Requirements for Generators Art 13 (4) and (5): Recommendations

November 2017

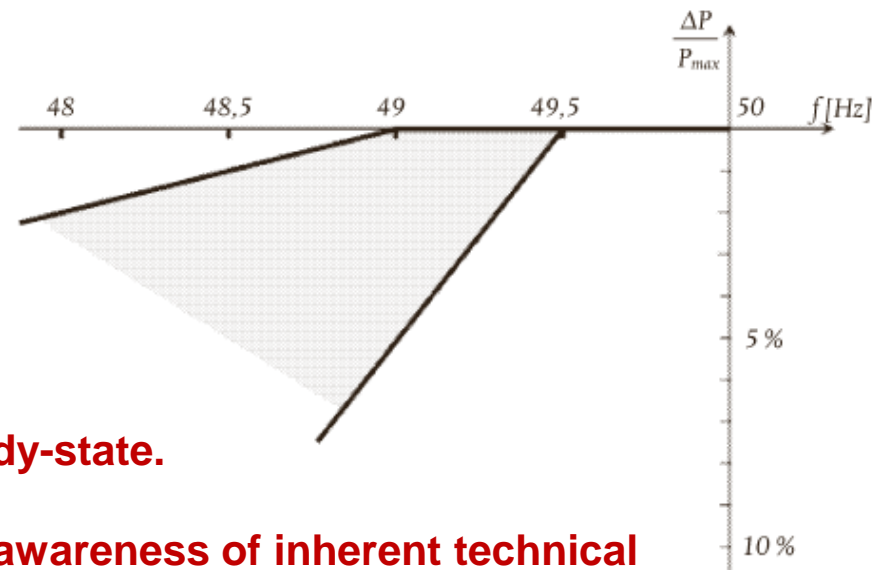
No requirement to dynamic behaviour.

The requirement can be interpreted as steady-state.

Art 13 (5) has been introduced to RfG after awareness of inherent technical constraints of some relevant technologies: equal to or prevailing Art 13 (4)!

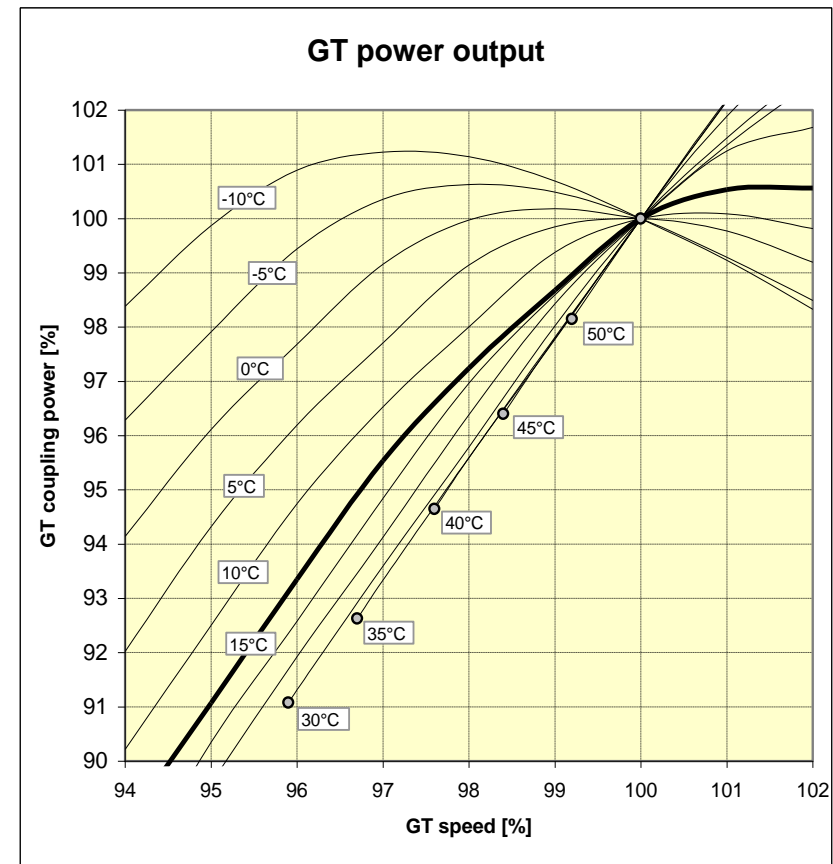
- Gas turbines output is influenced by different external factors. Depending on ambient conditions, power drop exceeds allowed values in Art 13 figure 2.
- Principle steady-state behaviour is shown in att. figure (values are only indicative!)
- Dynamic behaviour is worse since compensating power control loops need time to react to frequency drop (if reserve is available)

Technical and ambient limitations to be considered in requirement !
